From: [Symons, Brian D](#)
To: [Sager, John E - DNR](#)
Cc: [Gregory Prom \(MP\)](#); [Jamie Mehle \(SWLP\)](#); [Hughes, Erin](#); [Laszewski, Steve](#); [Saari, Christopher A - DNR](#)
Subject: RE: [EXTERNAL MAIL] SWL&P 100% Design
Date: Wednesday, December 28, 2022 5:16:49 PM
Attachments: [Attachments.html](#)

In the 90% Upland RAD comments, DNR requested nested piezometers with monitoring wells MW-3R and MW-4R and an additional monitoring well located near the City of Superior building in the area of SLIF-33. This e-mail is a response to DNR's e-mail dated December 27, 2022 regarding the nested monitoring wells and MW-29.

**UPLAND AREA REMEDIAL ACTION
 DESIGN DRAWINGS
 FOR THE
 FORMER MGP SITE**
SUPERIOR WATER, LIGHT & POWER
 WISCONSIN
 DOUGLAS COUNTY

CROSS-SECTIONS FORMER HORTONSHERE

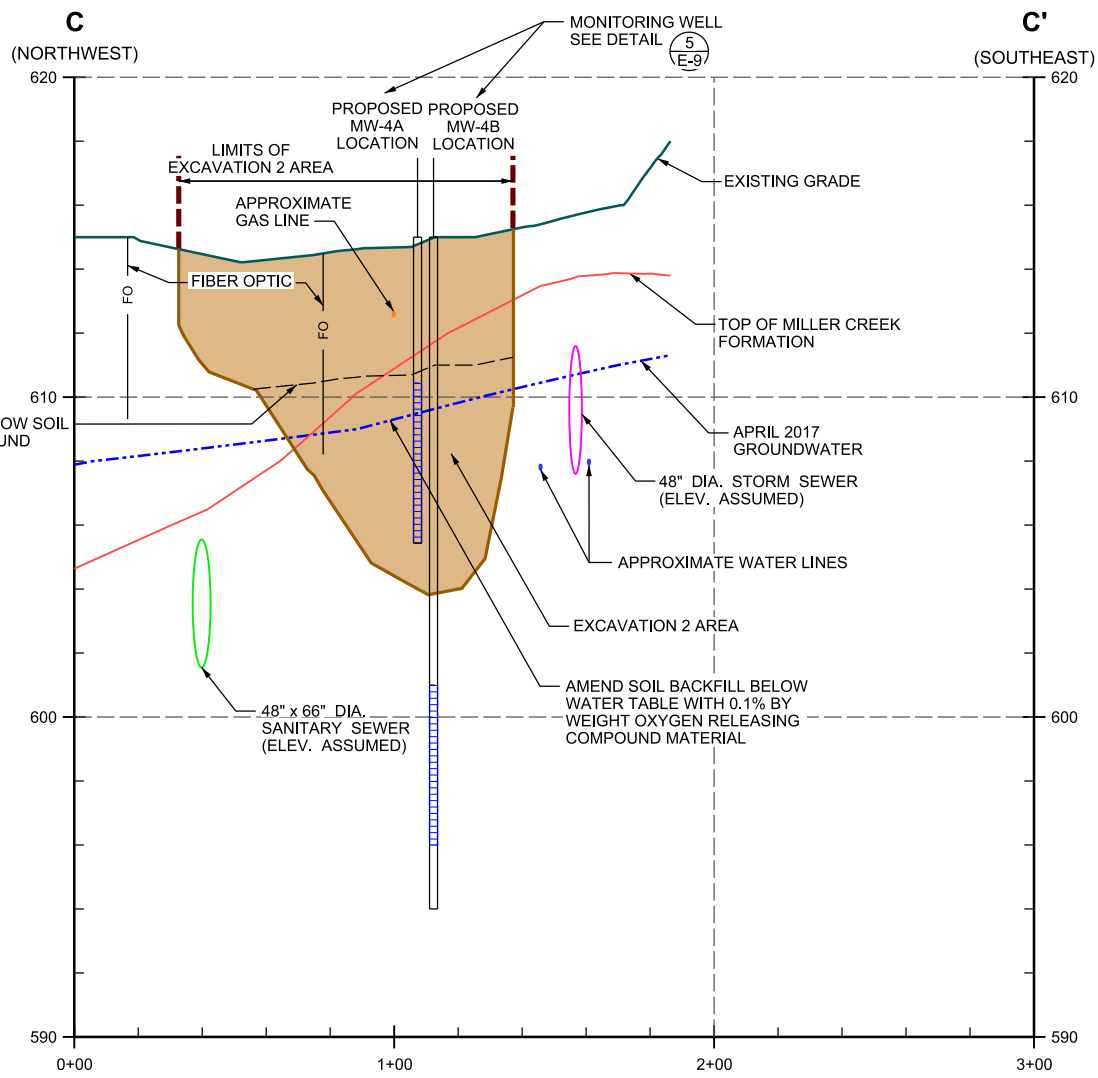
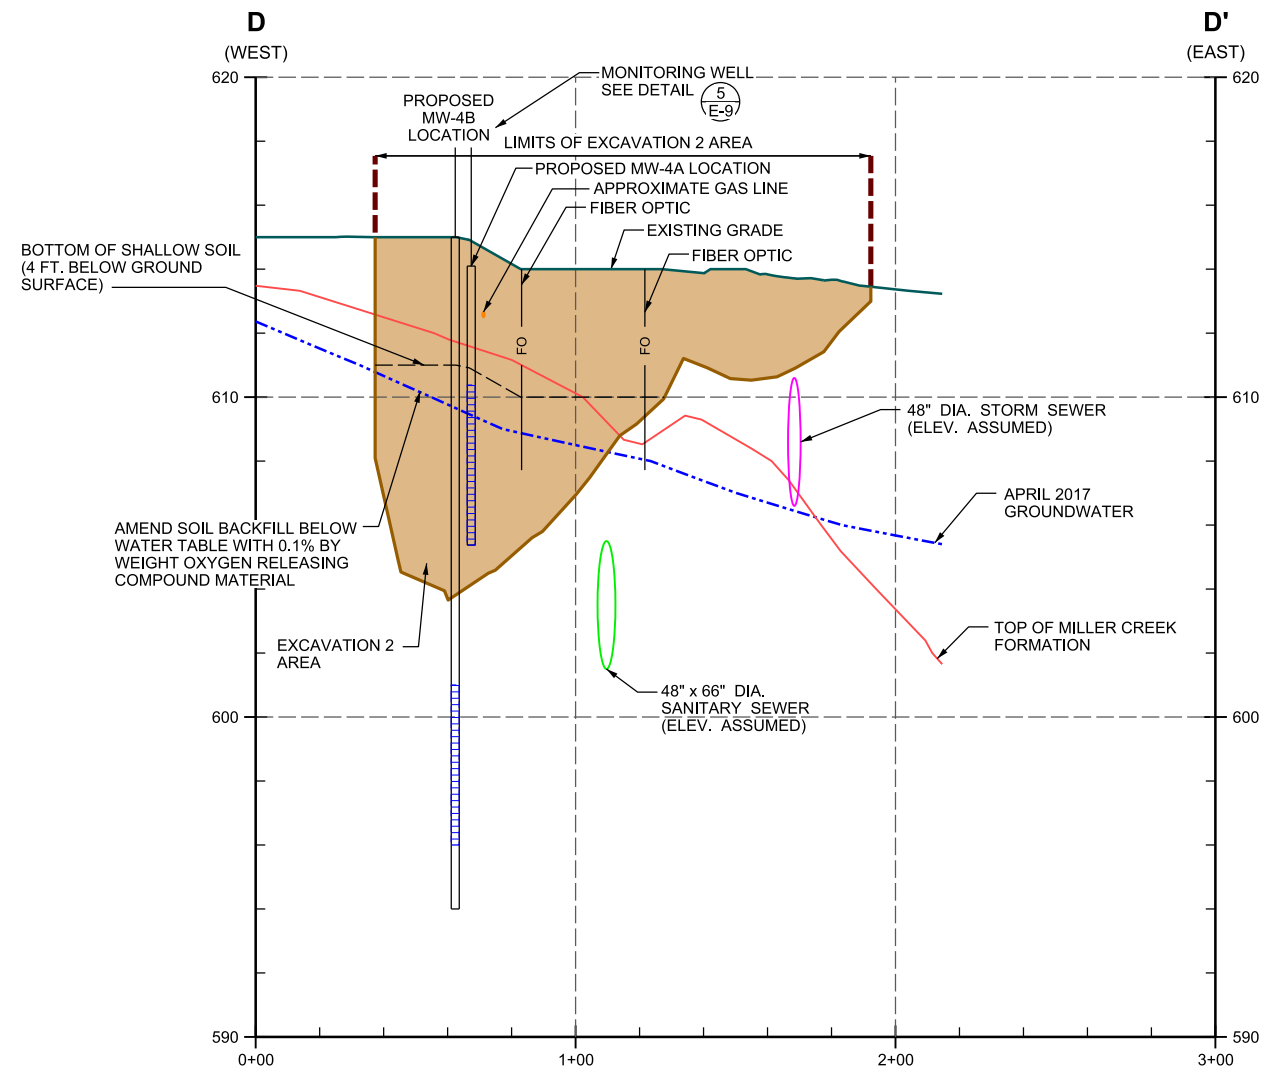
- the screened interval for MW-3B and MW-4B to be installed at approximately 596 to 601ft MSL adjusted to intersect sand layers, if present, and
- the location of MW-29 to be located further west near SLIF-33.

Final Drawings B-5 and B-6 are attached below.

- the cross-sections for MW-3B or MW-4B screened between 596 and 601 ft MSL (i.e., Drawings B-5 and B-6 in the RAD, ECSWMP, and OM&M Plan) and
- the location for B-29 near SLIF-33 (i.e., Drawing A-8 in the RAD, ECSWMP, and OM&M Plan; FSP Figure 4-1; and AMP Figure 2-1).
